DESIGN DRAWING
FOR DCR 1672

WISCONSIN PUBLIC SERVICE CORPORATION KEWAUNEE NUCLEAR POWER PLANT - UNIT NO. 1 CARLTON, KEWAUNEE COUNTY, WISCONSIN			
SCHEMATIC DIAGRAM TURBINE AUTO-STOP TRIP			
Designed By: Pioneer Service & Engineering Co. Chicago, Ill. 60606			
DRAWN CH	CHECKED 5-10-71 WES	SQUAD LEADER A.C. WEISS	
SCALE NONE	APPROVED J.E. COOPER, JR.	PROJECT NO. 237127A	
No. 237127A-E1475 H/1672-1		SHEET 1 OF 3

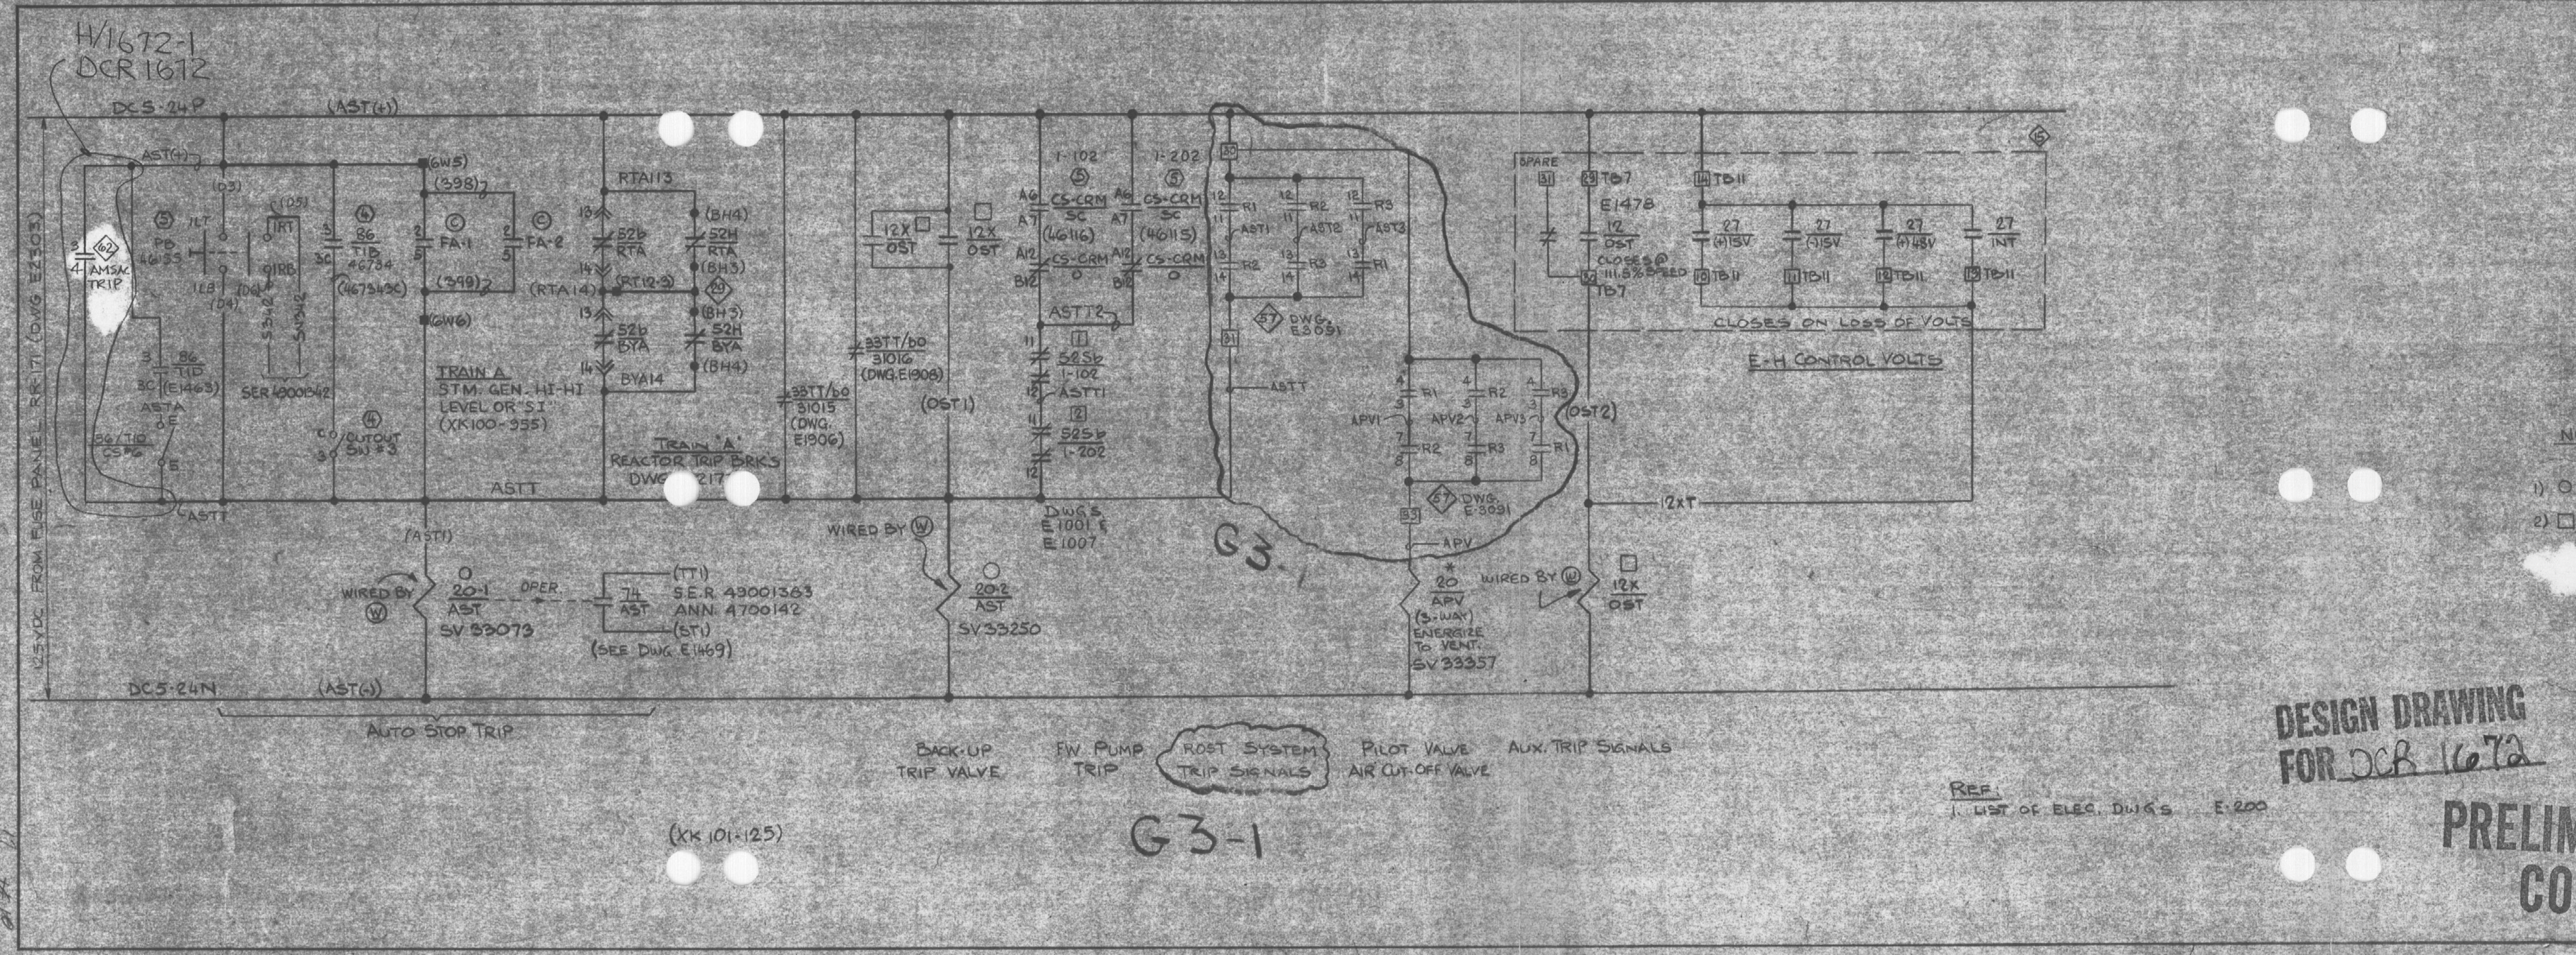
REVISIONS
H/1672-1 DCR 1672 AMSAC TRIP PER DCR 1672 BY L. ZEHREN 1-6-88
G/REVISED PER 3450, 3451 TRIP SEPARATION AS INDICATED IN DCR 323 KSP 5052 DWN: F.R. 9-2-76 CHKD: R.S. 9-13-76 APPD: R.S. 9-13-76 FILMED: 1-13-77
G8-11 PDS PROJ. N.P. 8101207 DCR 1008 REMOVED SCOT SYSTEM TRIP SIGNALS TO AUTO STOP TRIP & AIR CUT-OFF VALVE ADDED ROST SYSTEM TRIP SIGNALS TO AUTO STOP TRIP AND AIR CUT-OFF VALVE. DWN: L.V. 3-23-82 CHKD: R.S. 3-15-82 APPD: O.E. 3-15-82 PDS FILMED: 3-23-82 G1-2 INFO TRANS. PER DCR 1008 DWN: KNOPE 7-14-82 CHKD: S.F. 7-26-82
